# 2009 Corvette Z06 and ZR1: GM TechLink Article: Oil System Changes - LS7 and LS9

Changes have been made to the dry-sump engine oil system used in the 2009 Corvette

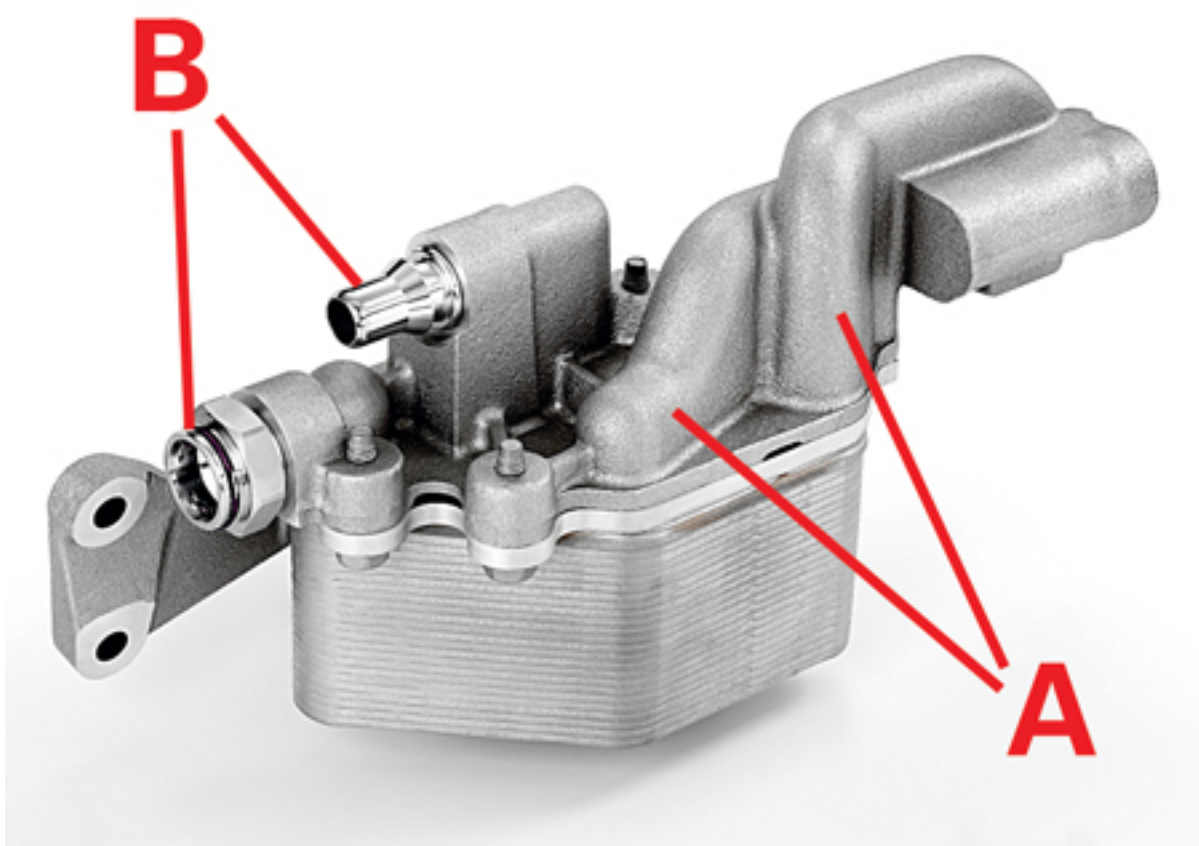
The dry sump system uses a dual gerotor oil pump, one rotor for scavenge and one rotor for supply (fig. 2) . The pump used on the LS9 produces greater volume and higher system oil pressure to provide adequate oil delivery under all conditions.

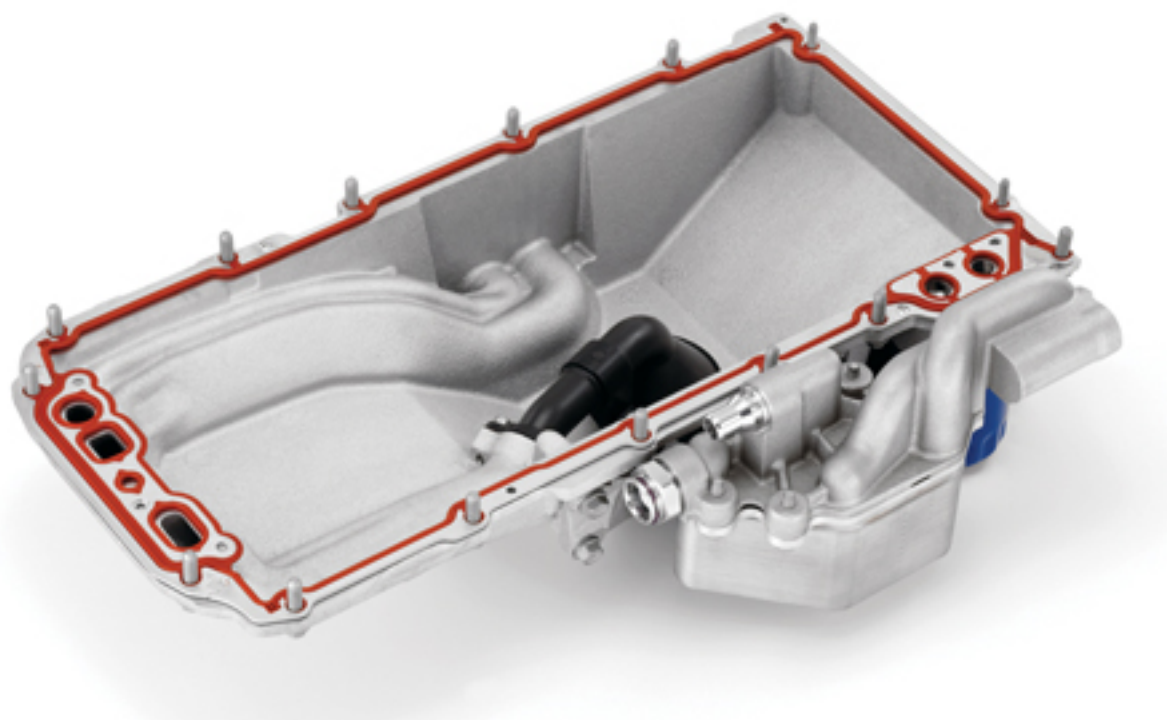
routed from the pan to an external engine oil cooler located in front of the coolant radiator. The 2009 LS9 uses the same pan with a different design oil cooler that is mounted on the left side of oil pan (fig. 5) .

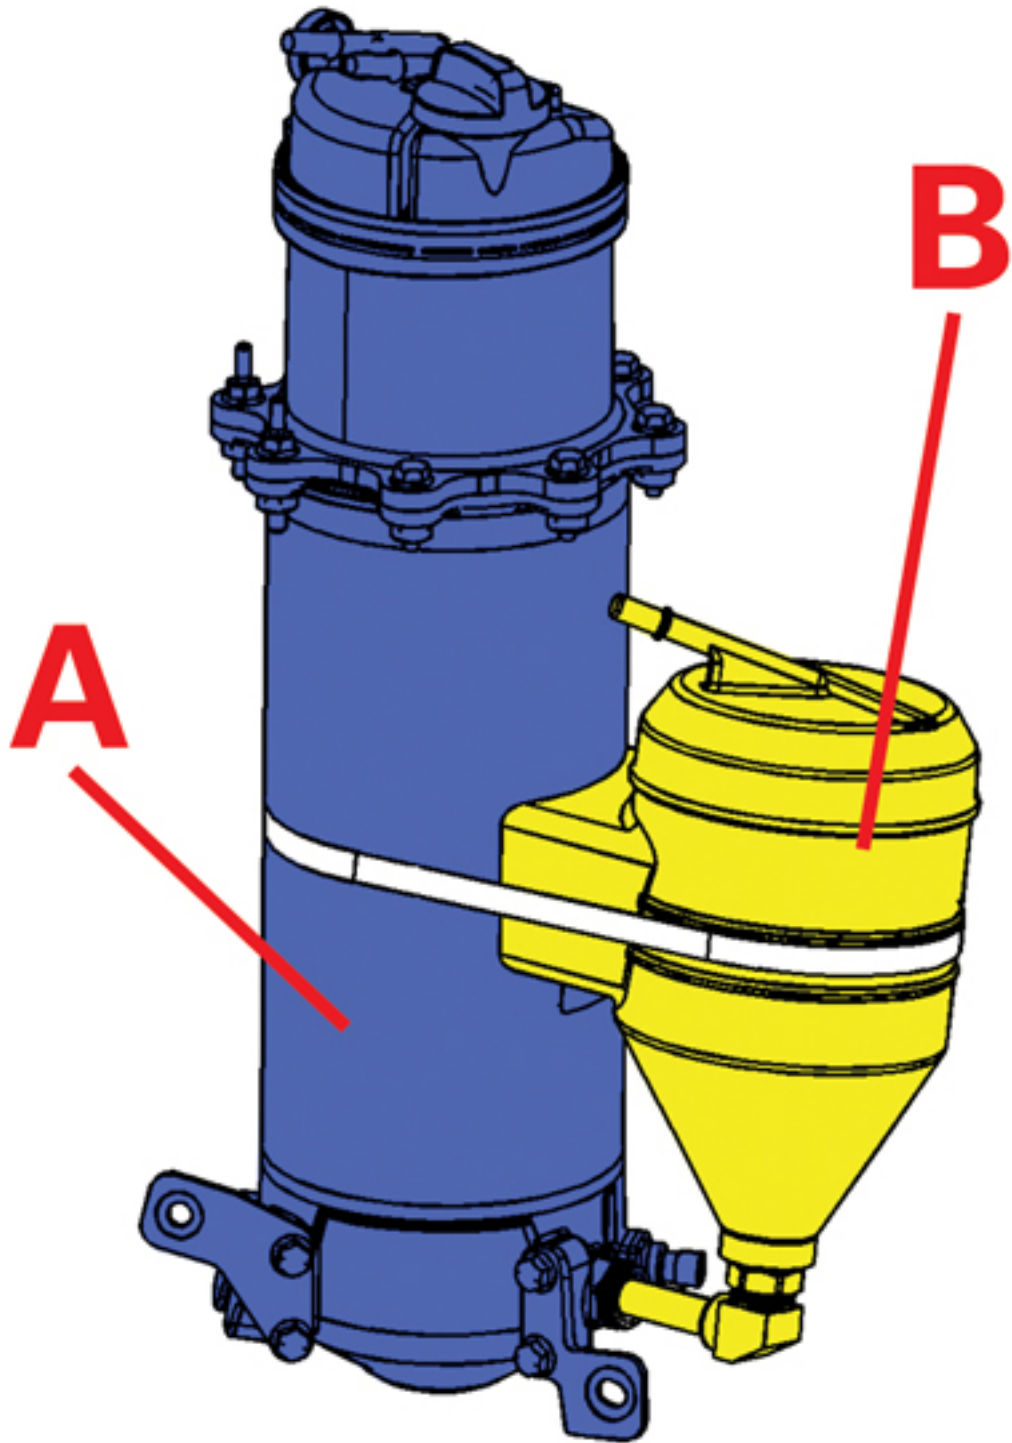
For both engines, the oil reservoir has been redesigned to increase the oil capacity of the system. Under extreme cornering loads such as experienced on a banked race track, extra oil capacity ensures that there is sufficient oil in the reservoir to avoid the ingesting of air due to slosh. A second tank is connected to the main tank by tubing (fig. 6) .
